IN LINE FUEL FILTER ENHANCEMENT

The MTX series rammer with Subaru ER12 engine will feature a new fuel filter with enhanced filtration performance and fuel flow rate.

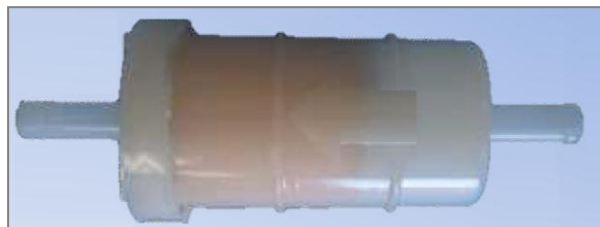
Production change effective as follows:

- MTX-60SD from serial number Y1091
- MTX-70SD from serial number Y1159
- MTX-80SD from serial number Y1729

Discontinued Fuel Filter
MQ part # (26365012A3)

New Fuel Filter
MQ part # (21E66001H1)

- Maximum particle diameter through filter = 32.0 μm
- Flow rate in gravity = 10.16 liter/hour
- Max flow rate by engine = 8.57 liter/hour

Tested with 650cc engine at 4000 rpm average fuel flow of MTX rammer ER12 engine at 4000 rpm is 1.46 liter/hour
